Jervois Street Reserve, South Plympton

FINAL CONSULTATION FINDINGS

April 2015

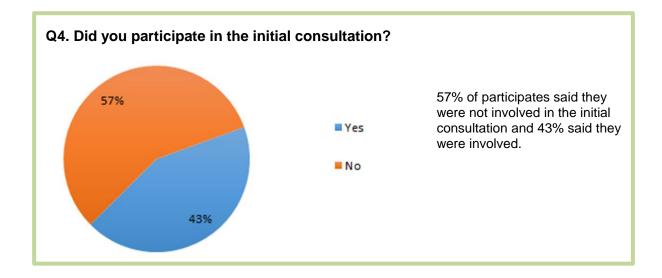
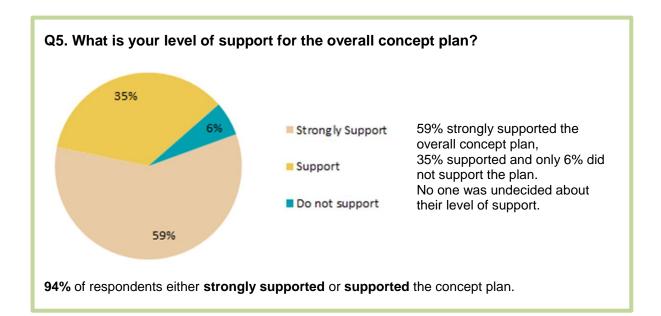
Respondent's reasons for answering Option A (facilities along Waterhouse) included: Jervois street is busier with cars, Jervois has less parking opportunities / space, Waterhouse is wider and better for parking, people drive faster down Jervois, where I live, Waterhouse is a more major road.

Respondent's reasons for answering Option B (facilities along Jervois Street) included: Liking the Northern aspect, use vacant block for car parking, less traffic on Jervois, the park is named Jervois, personal preference, personally easier to access and to remove Driveway link from Waterhouse by flipping the design.

Jervois Street, Option B responses:

- Provide car parking on vacant land next to the reserve.
 Response: the vacant land adjacent to the reserve is not owned by the City of Marion and is currently being built on with private dwellings.
- Flip the reserve layout to remove the driveway link from the Waterhouse Road side. **Response:** Driveway link has now been removed from the plan altogether.

Reserve Layout Orientation – given the feedback provided and the below dot points, Council have chosen to provide the playspace facilities along **Waterhouse Road, Option A**.

- Waterhouse is a wider road facilitating movement of traffic and parking to key reserve facilities.
- Jervois has a major services running under the footpath area which impacts on any future parking provision.
- Waterhouse has better passive surveillance from a resident and traffic perspective.
- Design orientation with southern aspect of facilities afternoon sun glare for sporting facilities provided and shade provision.
- Future parking provision along Waterhouse will also potentially slow traffic as people are entering and exiting parking.
- Resident input and ownership strong along Waterhouse Road.
- Residents understanding and general acceptance of the provision of facilities within the park adjacent to properties.
